SOUTH TEXAS COLLEGE

REQUEST FOR PROPOSALS ADDENDUM NO. 1
--

RFP NUMBER: 18-19-1060
**RFP TITLE: NURSING AND ALLIED HEALTH CAMPUS –
RESURFACE OF PARKING LOT #1**

Addendum Issue Date: April 18, 2019

SHEET
C7

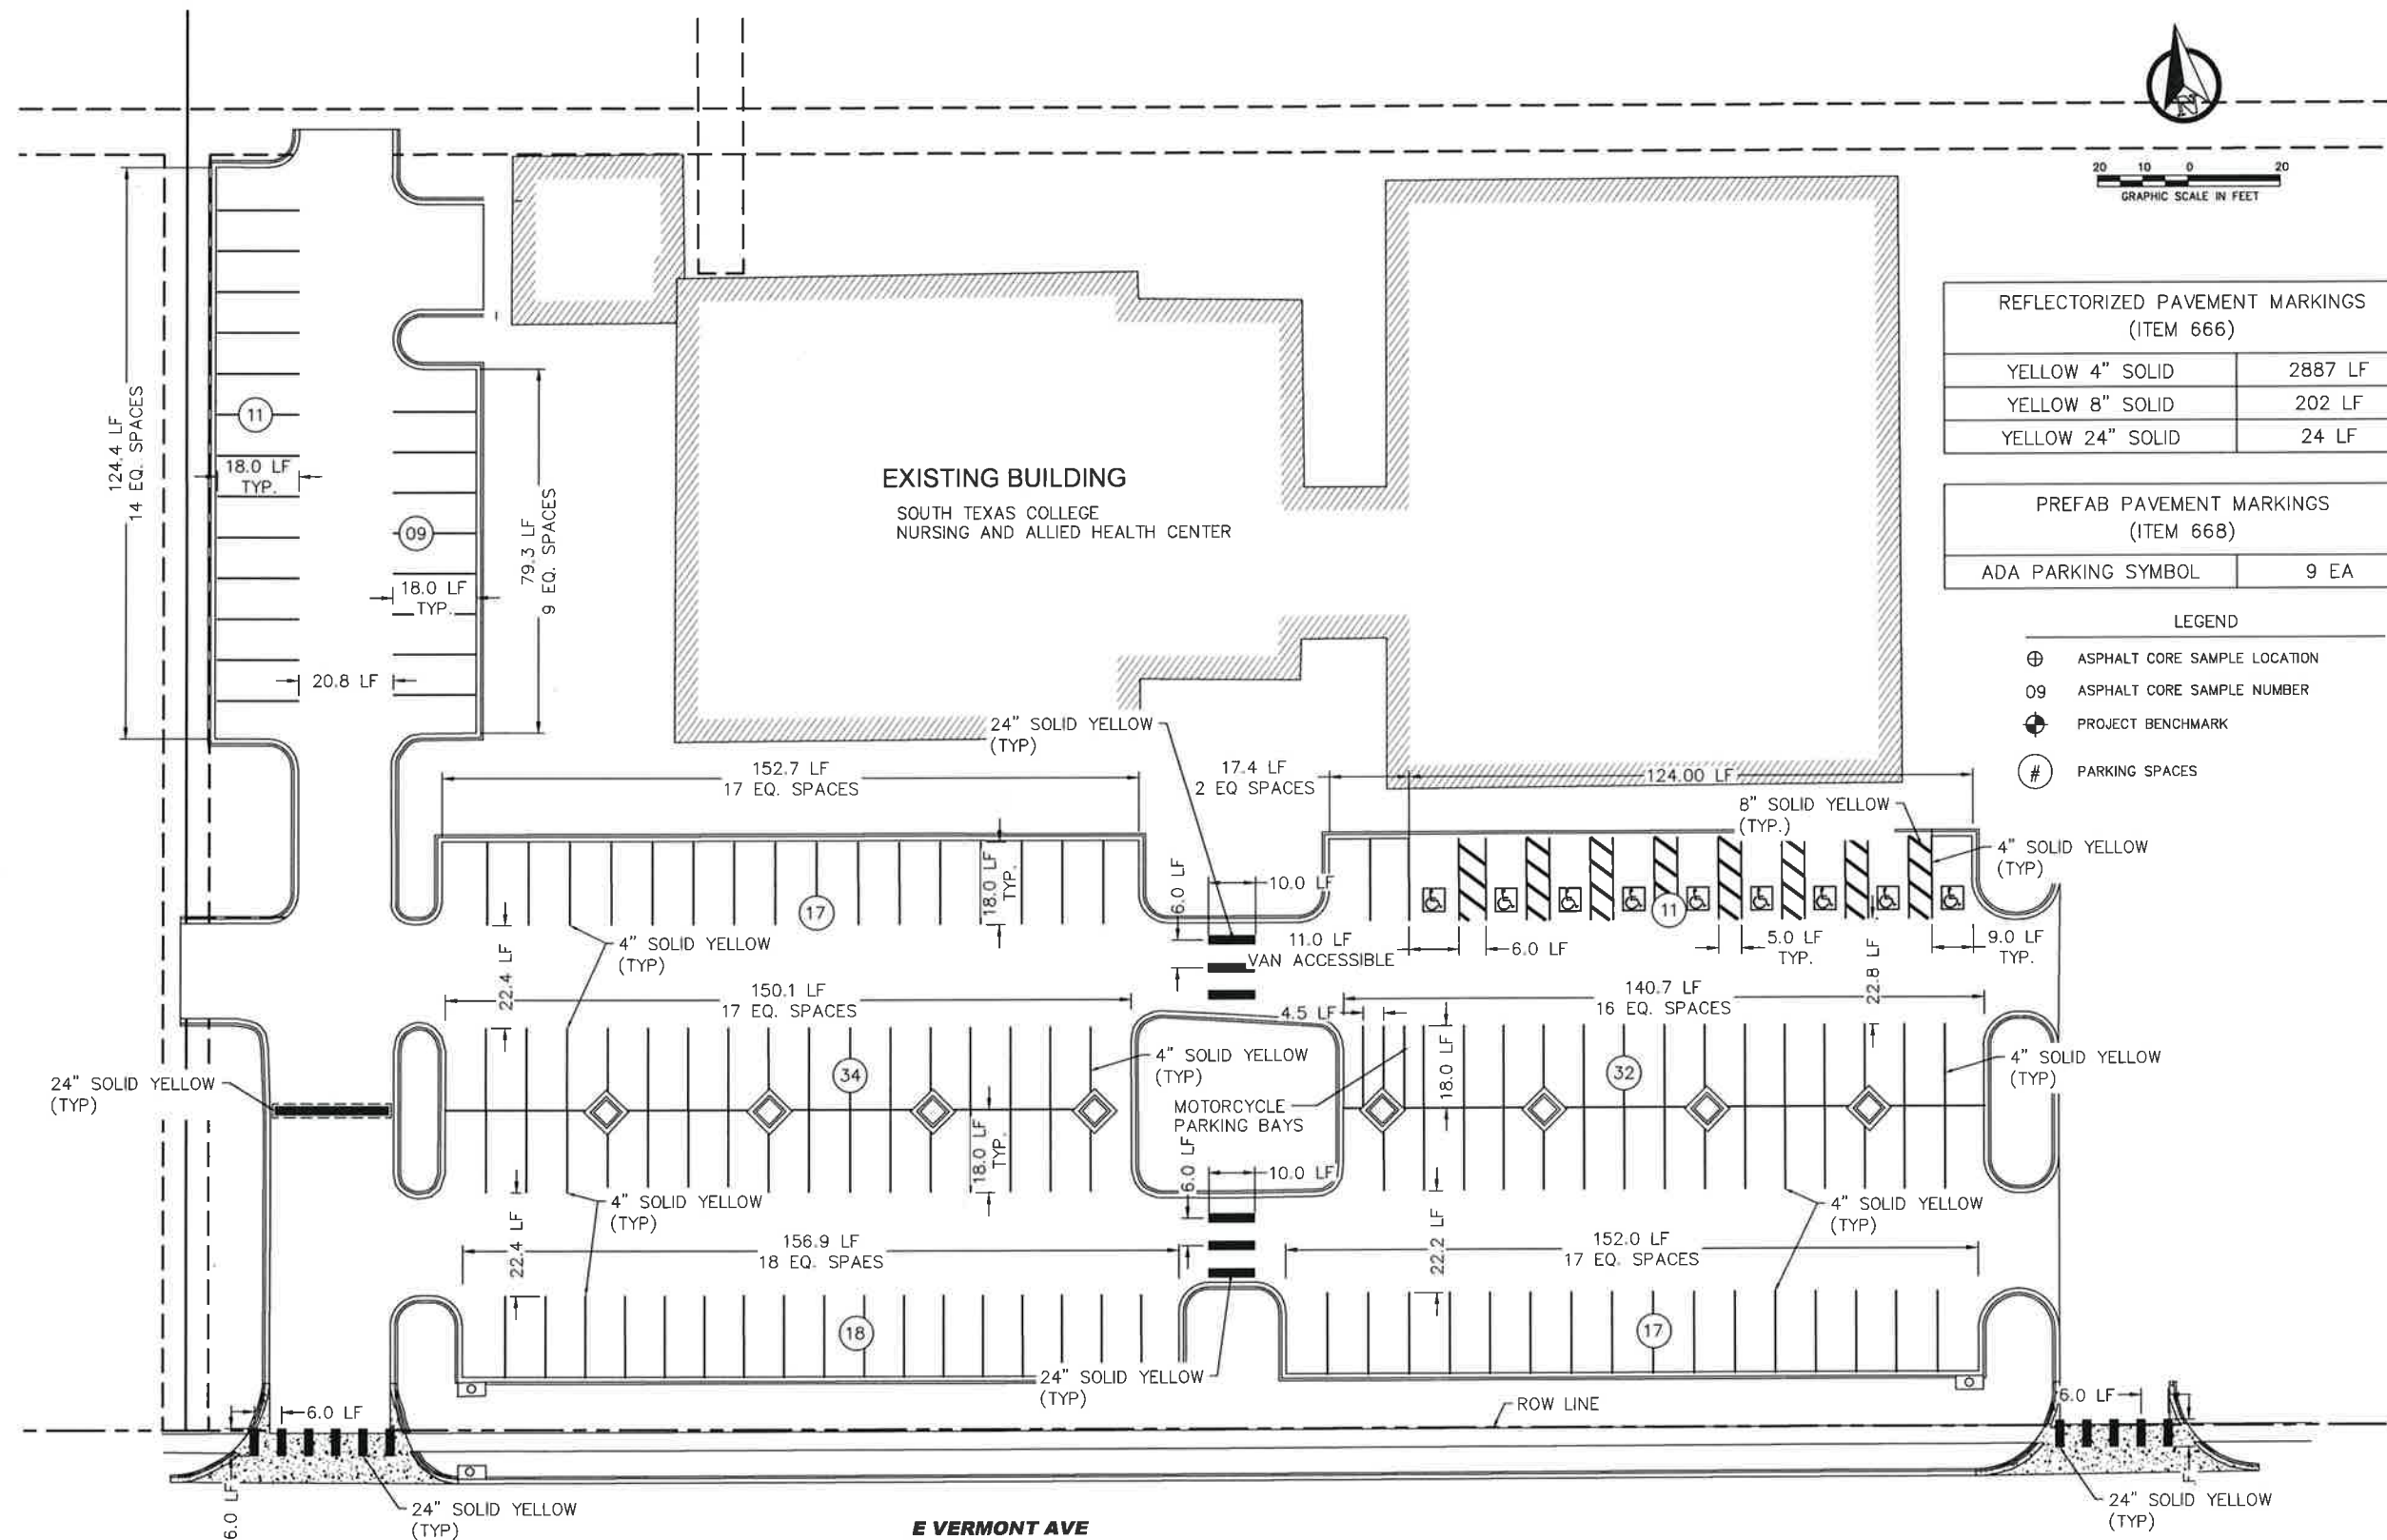
- Pavement marking widths have been identified on the Striping Plan. See attached amended sheet C10.
- Pavement markings for parking stalls shall be Yellow – Hot Applied Thermoplastic.
- Handicap parking stall widths have been identified on the Striping Plan. The Striping Details have been updated to match the proposed Striping Plan. There is one Van Accessible Parking Stall of 11 FT width, the remaining handicap stalls are 9 ft width. See attached amended sheets C10 and C11.
- The R7-8 Signs (Handicap Sign) are existing and shall remain in place. The Striping Details have been updated to match the proposed Striping Plan. See attached amended sheets C11.
- The table found on sheet C7 represents the existing ACP thickness. The entire parking lot will be milled and overlaid 1.5 inches.
